Global Specialised Garments Ltd Unit 02

12-13P Kalurghat Heavy Industrial Area, Chittagong
(22.383726N, 91.868526E)

28th November 2015

Observations

Observation: Lateral instability of elements on façade wall

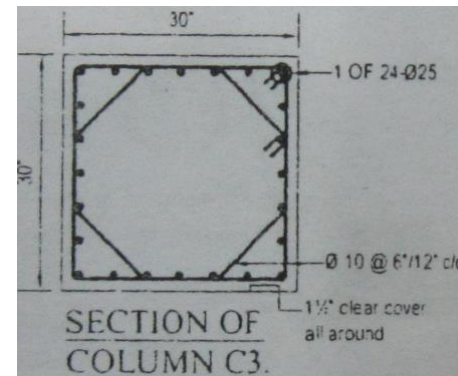
Lack of stability in façade wall brickwork features

Façade wall with brickwork fins unrestrained over 3.67m floor-to-ceiling height force

Item No.	Observation	Recommended Action Plan	Recommended Timeline
6	Lack of stability in façade wall brickwork features	Building Engineer to verify the stability of the brickwork 'fin' feature of the façade.	6-weeks
7	Lack of stability in façade wall brickwork features	Provide adequate restraint to ensure stability of brick façade features	6-months
8	Loading control signage in Storage areas do not correspond to stated design load	Building Engineer to assess loading in storage areas and the capacity of the floor structure to accommodate that loading	6-weeks
9	Loading control signage in Storage areas do not correspond to stated design load	Provide Load Plan indicating the maximum storage load that can be accommodated by the slab structures	6-months
10	Loading control signage in Storage areas do not correspond to stated design load	Post notices at all Storage areas indicating maximum storage loading for each area	6-months
